ADDENDUM NO. 1
March 4, 2022

DLH Runway 3-21 Lighting and Signage Replacement
City of Duluth No. 21-4401
AIP No. 3-27-0024-072-2022
Duluth International Airport (DLH)
Duluth Airport Authority

SEH No. DULAI 164242

SHEET
E-107

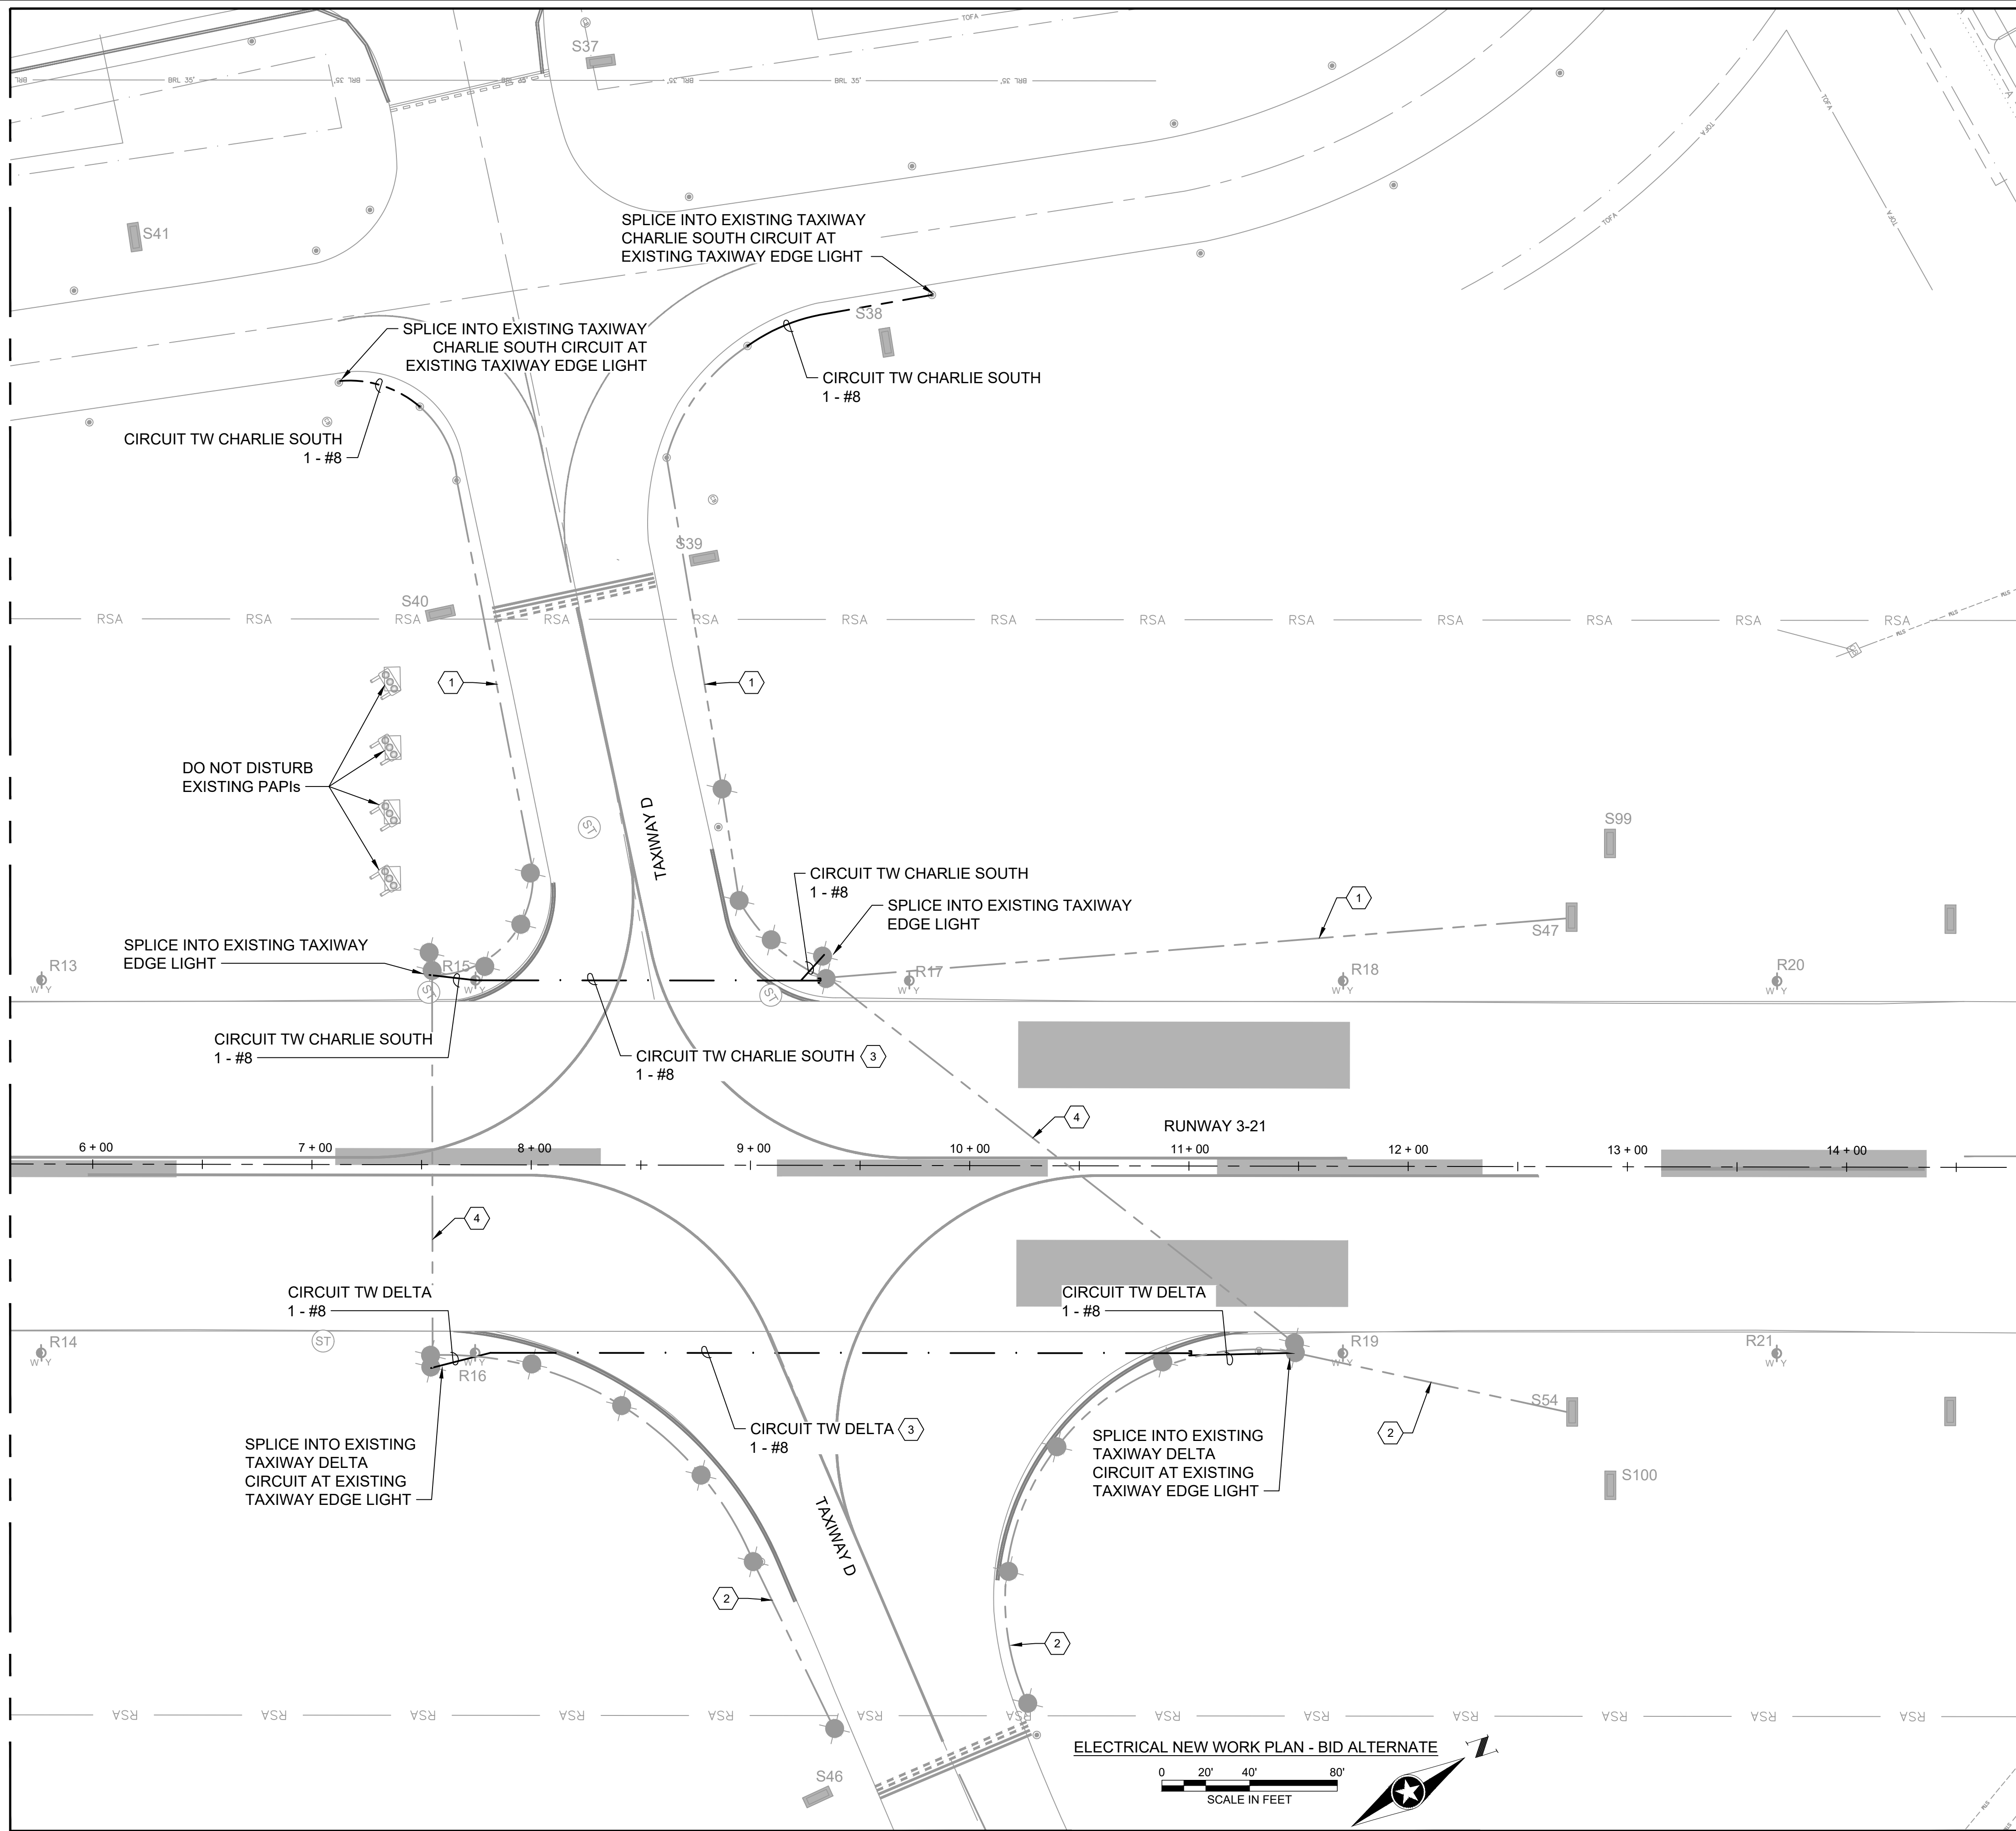
13. Drawing E-107 Electrical New Work Plan 7 – Bid Alternate Sign Schedule Added. Signs affected by alternate bid sign schedule are identified in the Electrical New Work Plan and notes have been updated.
